**ADDENDUM NO. 3**

Plans & Specifications for: Cedarwood Playground, Waltham, MA

In accordance with documents prepared by: Carolyn Cooney & Associates

**CITY OF WALTHAM  
 CEDARWOOD PLAYGROUND  
 25 INTERVALE ROAD  
 WALTHAM, MA 02453**

SKL-3

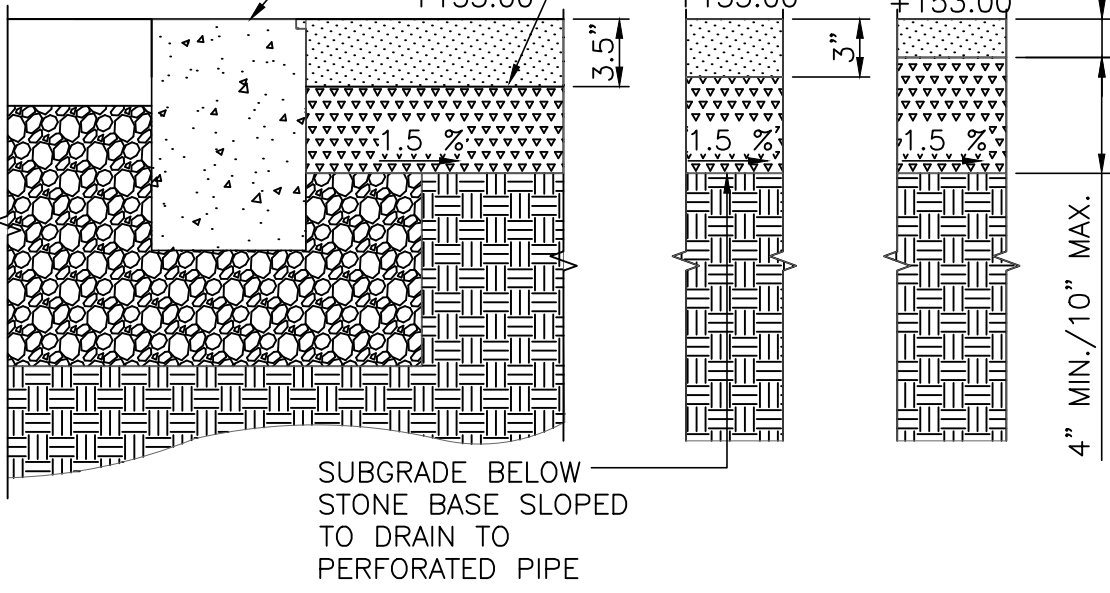
- Q4. *Why is there a range given of 4" minimum to 10" maximum for the crushed stone base for the safety surfacing?*
- A4. The subgrade of the stone base shall be sloped to drain to a subdrain, therefore the bottom elevation of the stone base varies. The depth of safety surfacing varies, therefore the top elevation of the stone base varies. Refer to SKL-3 thru SKL-7.

TOP OF STONE BASE FLAT FOR EACH DEPTH OF SURFACING, ELEVATION VARIES

SUBGRADE BELOW STONE BASE SLOPED TO DRAIN TO PERFORATED PIPE
